Thank you for another opportunity to comment on the lengthy EIS for the major road transport initiative of the proposed Northern Beaches Link.

I am submitting my **objection** to the Beaches Link, together with clear actionable initiatives I expect the Government will adopt to mitigate the impacts, should the project proceed.

## Northbridge Progress Association submission to Transport NSW regarding Beaches Link Tunnel EIS - Concerns and Recommendations

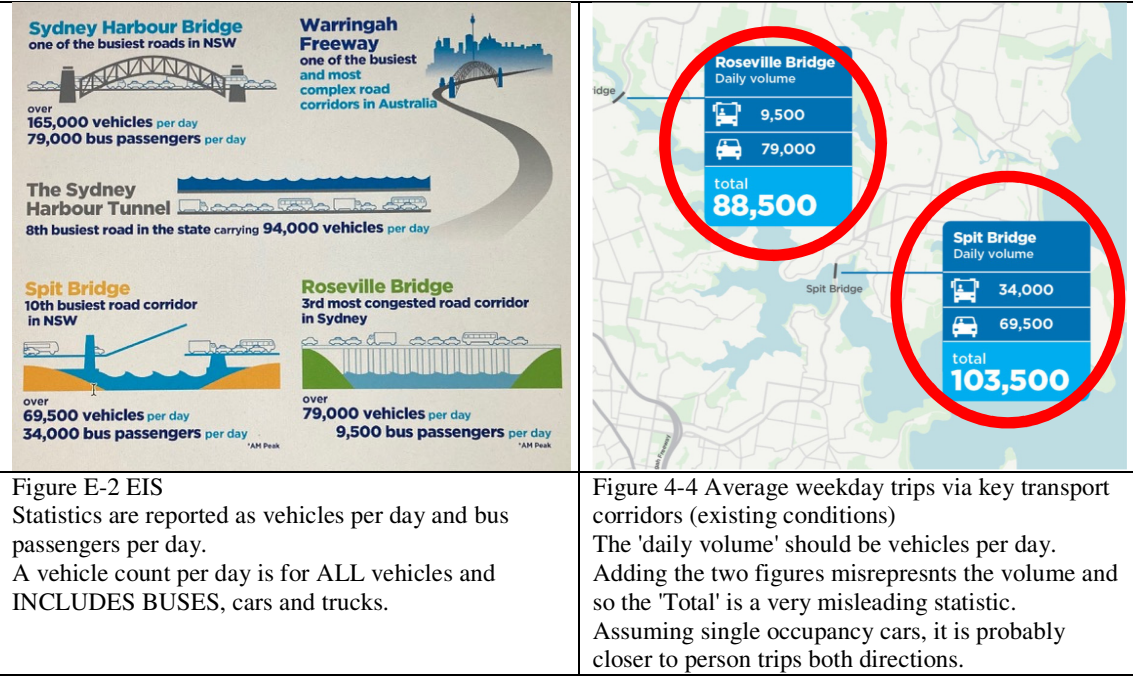
However, I take issue with the misleading information reported in the EIS regarding current traffic movements. This is a fundamental piece of information that has exaggerated the current levels and basic need for a solution.

This information should have been corrected in the EIS.

What is evident from these 2 figures is that the Roseville Bridge corridor has much less bus patronage relative to the Spit. The Sydney's Bus Future (2013) strategy for Bus Rapid Transit for this corridor should be a priority that would alleviate trips demand from Northern Beaches.
